Project	IEEE 802.16 Broadband Wireless Access Working Group < http://ieee802.org/16 >	
Title	Adding new REG/SBC capabilities to wman2IfMib	
Date Submitted	2006-09-22	
Source(s)	Joey Chou Intel Corporation	[mailto:joey.chou@intel.com] [mailto:jose.p.puthenkulam@intel.com]
Re:		
Abstract	This contribution proposes the changes being included to wmanIf2Mib in order to support new capabilities that have been introduced in REG and SBC messages in IEEE 802.16e 2005.	
Purpose	Adoption	
Notice	This document has been prepared to assist IEEE 802.16. It is offered as a basis for discussion and is not binding on the contributing individual(s) or organization(s). The material in this document is subject to change in form and content after further study. The contributor(s) reserve(s) the right to add, amend or withdraw material contained herein.	
Release	The contributor grants a free, irrevocable license to the IEEE to incorporate material contained in this contribution, and any modifications thereof, in the creation of an IEEE Standards publication; to copyright in the IEEE's name any IEEE Standards publication even though it may include portions of this contribution; and at the IEEE's sole disc

Figure 20—wman2IfBsCps Structure

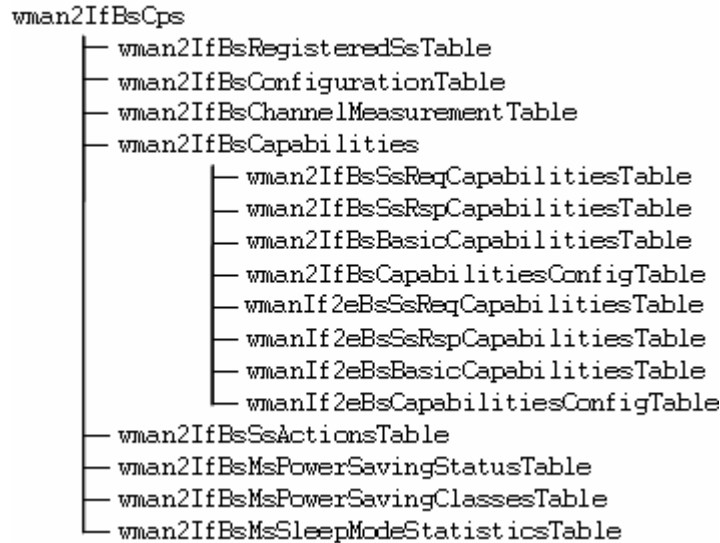
9 *[Replace Fig 20 with the following:]*
